SB-A500A-2810-01

Revision:	
Type:	EA 400
Model:	EA 400-500
Project:	A500A-16-09
Date:	06. Mar. 2017

SERVICE BULLETIN

FUEL CAP MODIFICATION

Figure 1: Modified fuel cap and corresponding tool (in grey)

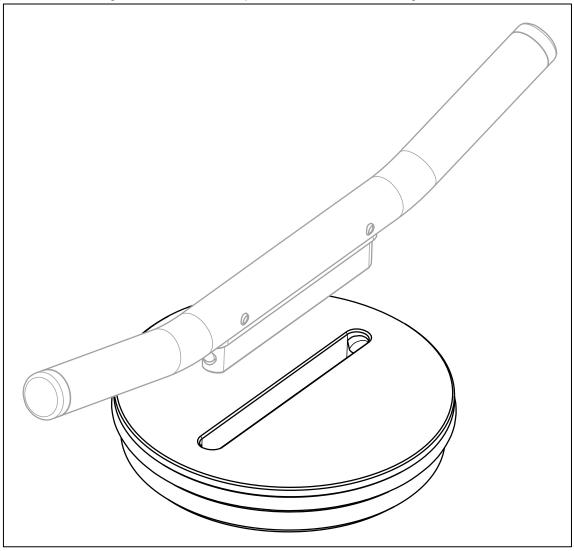
This service bulletin is issued to present a modified version of the fuel cap. The shape of the recess is modified in a way that it can be used together with a tool for opening and closing the fuel cap more easily. Thus the change is only profitable in combination with this tool. (Refer to SB-A500A-0210-01)

In addition to the modification of the fuel cap recess the O-ring has been changed to a standard MS28775 O-ring which affects the gland within the fuel cap and the installation drawing.

Remove all four fuel caps EA-6B215.02 on top of the wing and the installed O-rings OR4007600-V80G2.

Install the new modified fuel caps 500-2811-009-101 together with the corresponding O-rings MS28775-337.
